MIL-P-38005B (USAF)
AMENDMENT 4
1 JULY 1981
SUPERSEDING
AMENDMENT 3
3 October 1977

MILITARY SPECIFICATION

PITOT-STATIC TUBE

This amendment forms a part of Military Specification MIL-P-38005B (USAF) dated 4 November 1965.

FIGURE 1. PITOT-STATIC TUBE CONFIGURATION

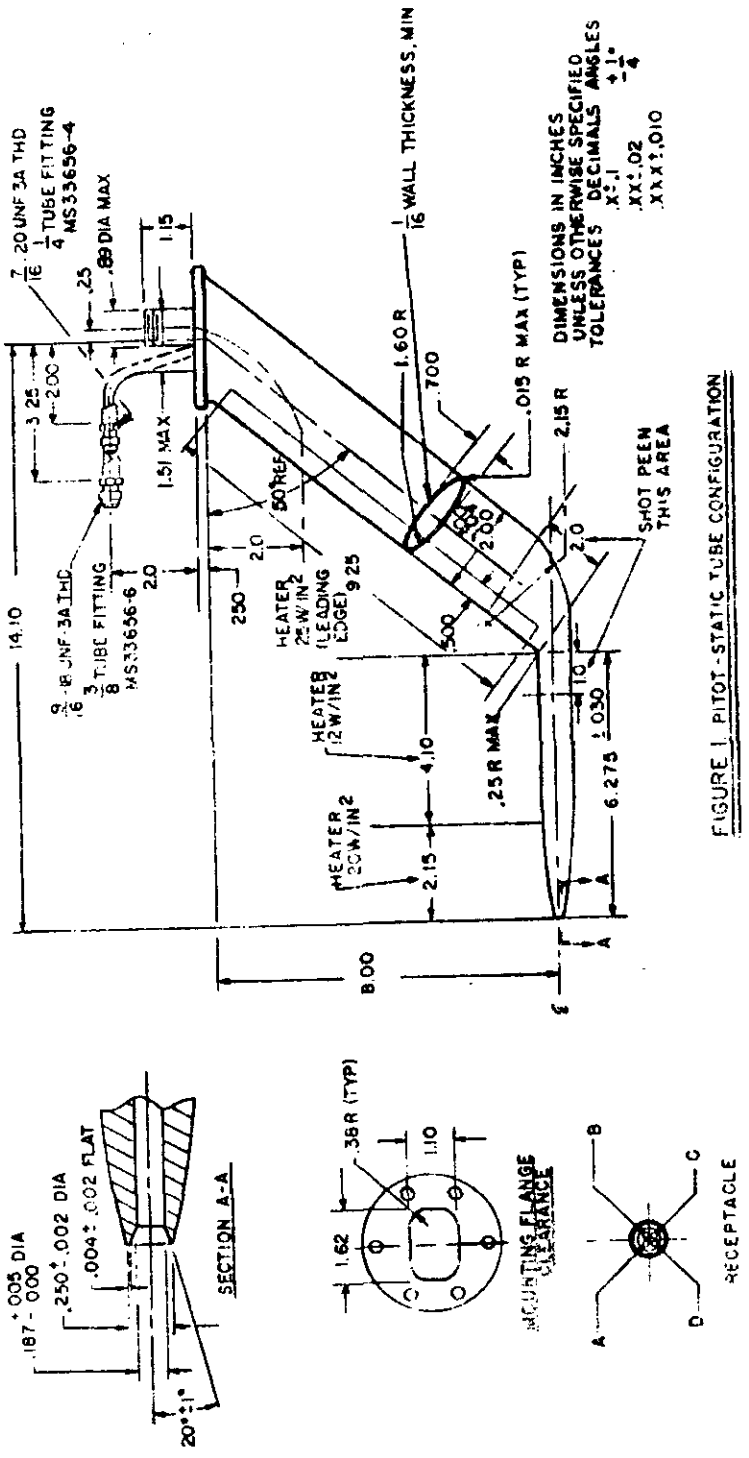
Figure 1: Delete old "Figure 1" and substitute new "Figure 1" as attached in this amendment.
